ORDER UNDER SECTION 96 (2) OF ACT. III OF 1901.

PROPOSED BUNGALOW ON PLOT NO 18 JM2

Re: Plot No. 18, Sheet 2, Jamshed Qr.

With reference to your application dated 25.7 1929.,
with a plan for the proposed building/additions and alterations on plot
No. 18, Survey Sheet No. Sec 2 quarter,
I have the honour to inform you that until the following requirements are
complied with, the plans cannot be passed:—

SECTION OF R.C. BEAM & COLUMN.

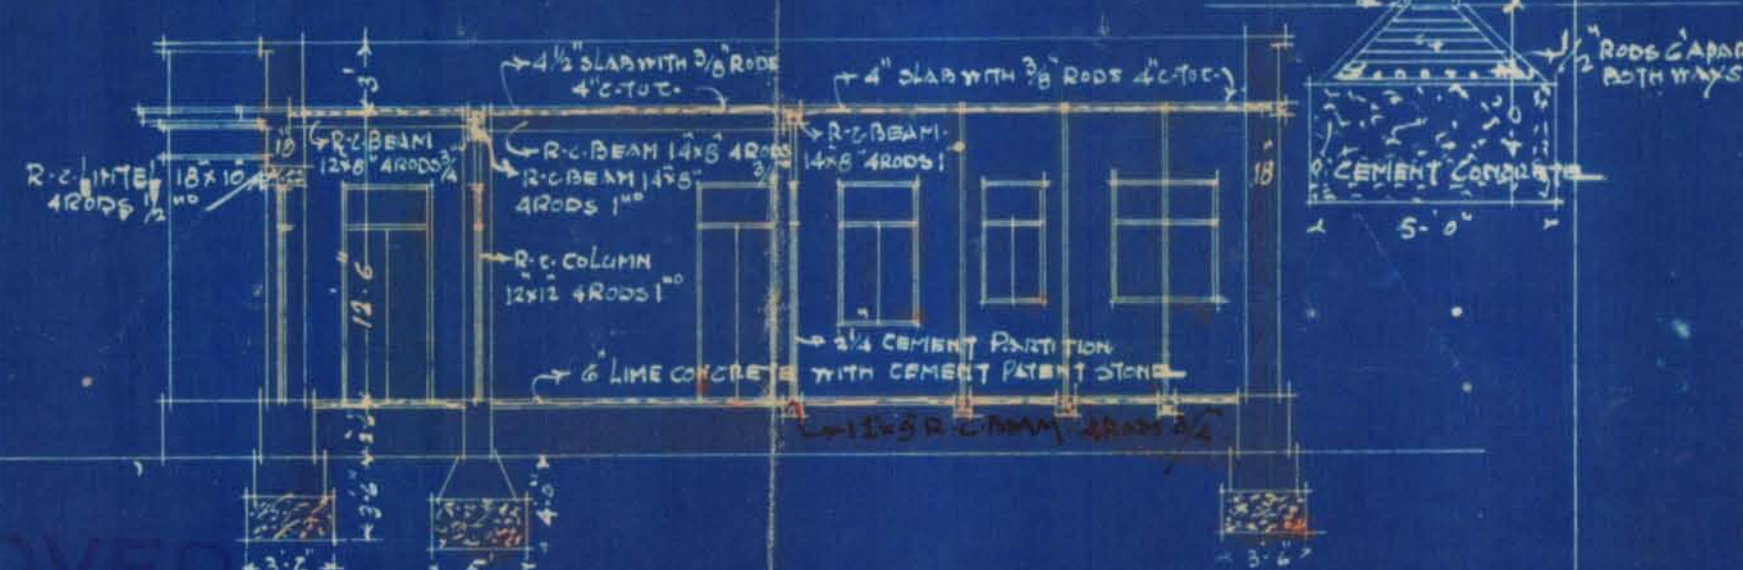
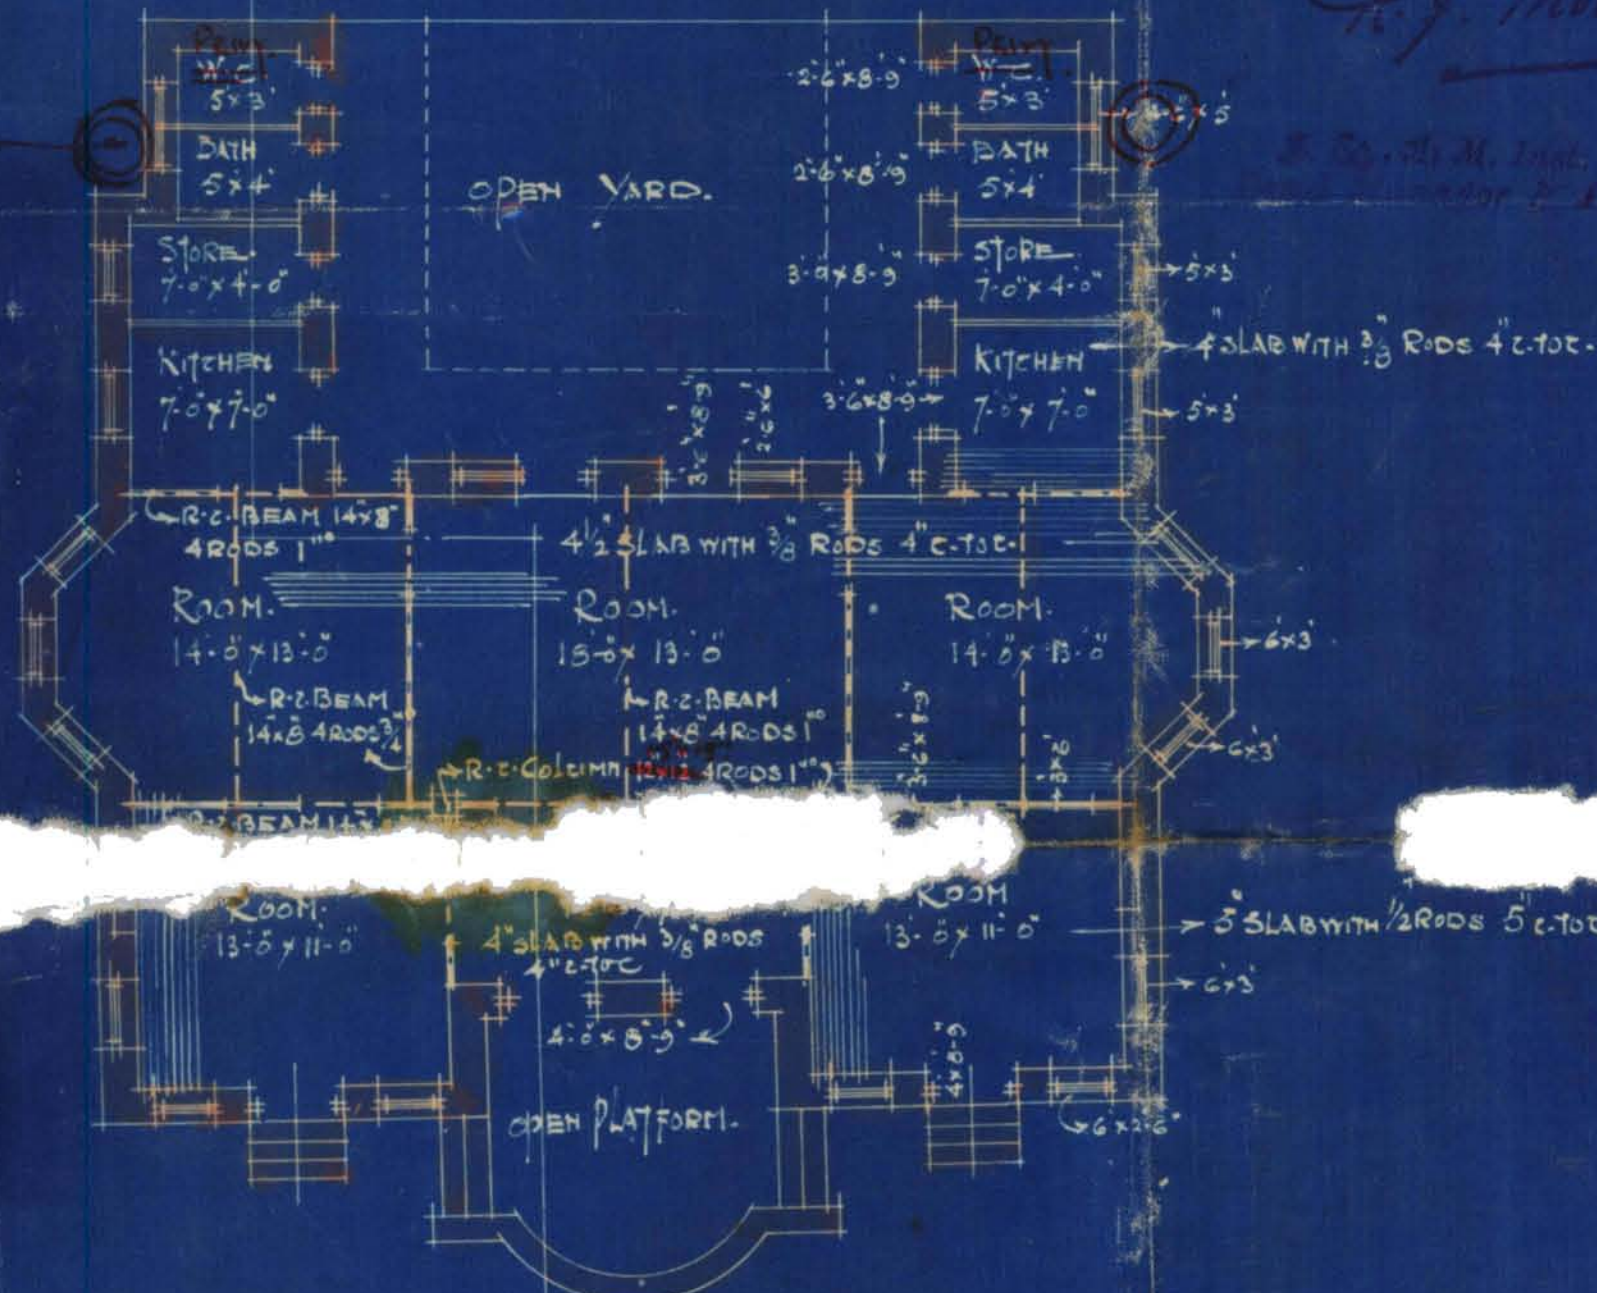
- (1) W.C should be substituted by Privy with catch-pit.
- (2) Plot should be numbered 18 Sec 2.
- (3) 12"x12" column be made 15"x15" to take floor in future.
- (4) Size of beam below Partition wall to be specified.
- (5)
- (6)
- (7)
- (8)
- (9)

With reference to your memo No. L.M.A.B.S. 4650 dated the 13th instant, we beg to return here-with the plans duly amended and shall feel obliged if you will kindly return the same duly approved.
